DA2019.223.2  
3 December 2020

## Section 4.55(1A) Planning Report

Modification to Approved Demolition, Alterations and Additions to  
Existing Educational Establishment

Trinity Grammar School – 115-127 The Boulevard, Strathfield

Figure 5 Proposed mechanical equipment screening – extract from east elevation

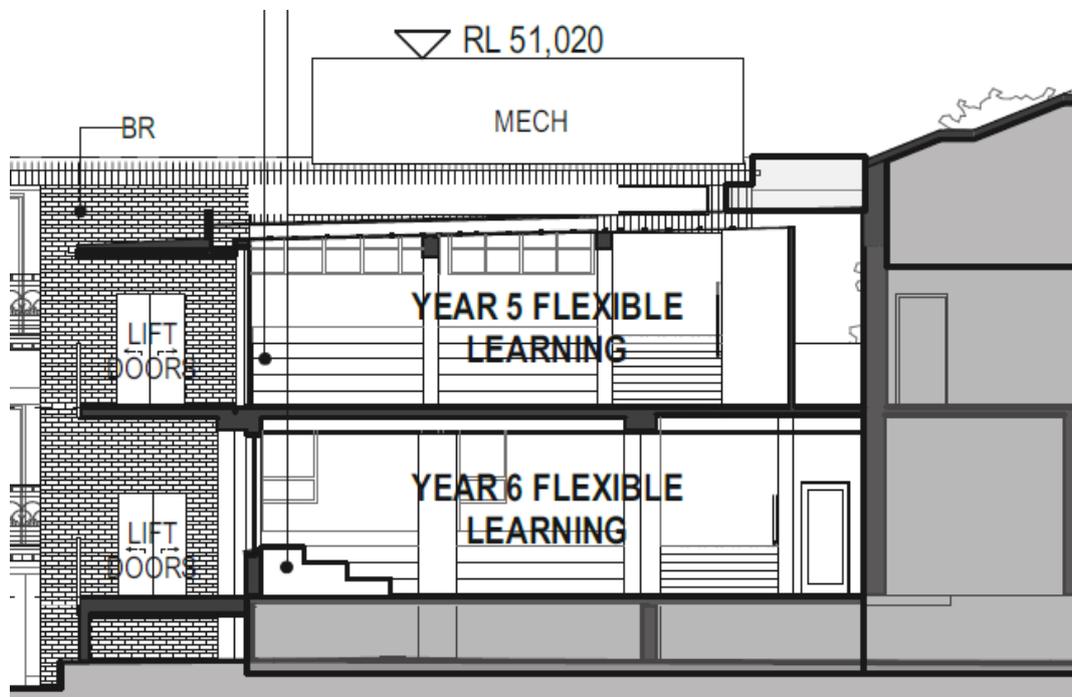
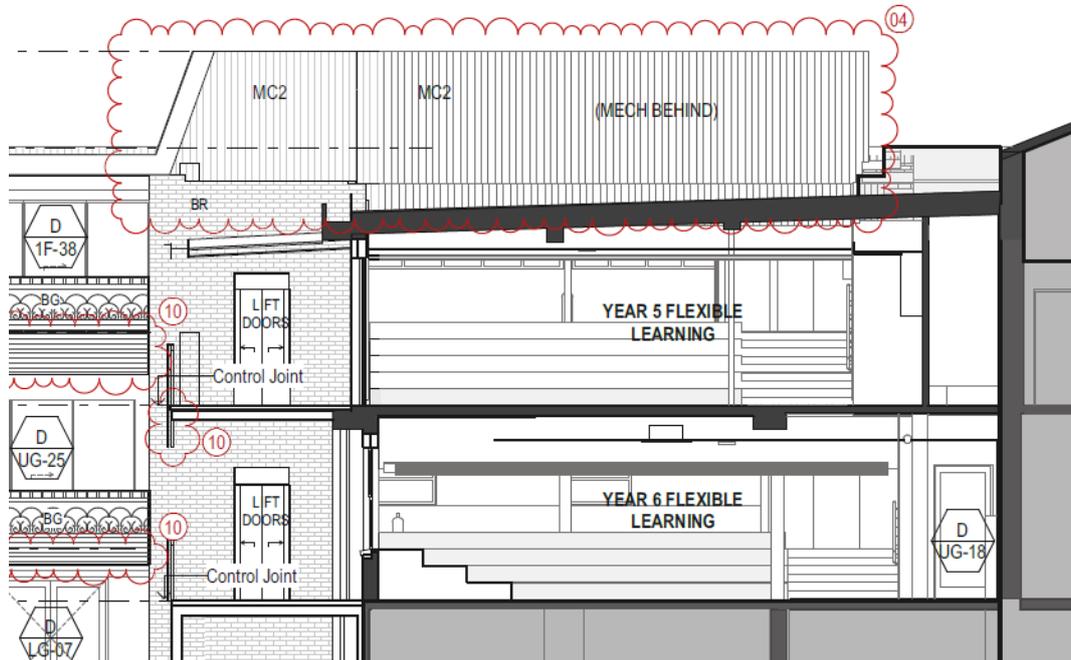
The most notable modification is the changes proposed to the shape of the mechanical equipment screening. **Figure 4** below is an extract from the approved eastern elevation with **Figure 5** showing an extract from the proposed modification to the eastern elevation.

As discussed in **Section 3.1** of this report, the mechanical plant screening/enclosure is proposed to be modified (as shown in **Figure 4** and **Figure 5** respectively). As seen in **Figure 6** below, the screen/enclosure is slightly larger than that previously approved and incorporates a ‘sloped’ element, consistent with the ‘sloped’ features of the façade of the southern elevation. This ‘ties’ the screen/enclosure with the design of the building and creates improved

Figure 6 Proposed mechanical plant screen/enclosure – east elevation extract

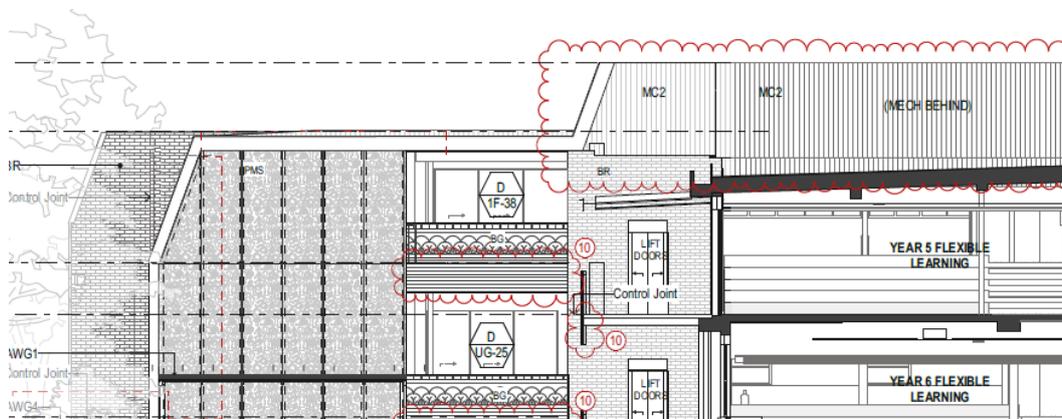
and aesthetically pleasing massing to the built form of the proposal whilst also being functional in terms of screening plant equipment.
